SAM D11 Series Family Silicon Errata and Data Sheet Clarification

Data Sheet Clarifications

The following typographic corrections and clarifications are to be noted for the latest version of the Device Data Sheet (Atmel-42363H-SAM-D11-Datasheet_09/2016).

FIGURE 35-3: BOD33 HYSTERESIS OFF

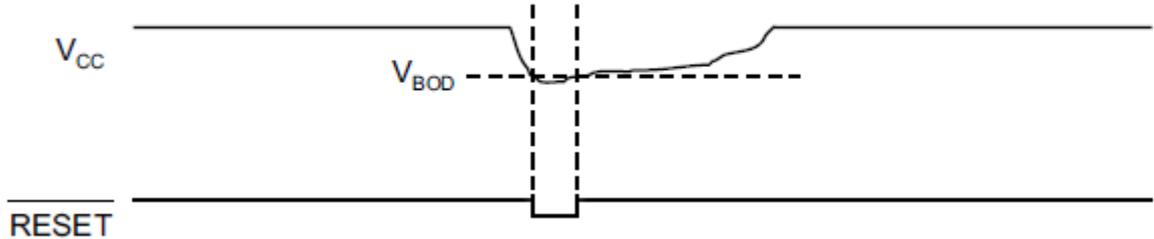
Figures 35-3 and 35-4 have an incorrect reset Polarity value. The correct figures are displayed as follows:
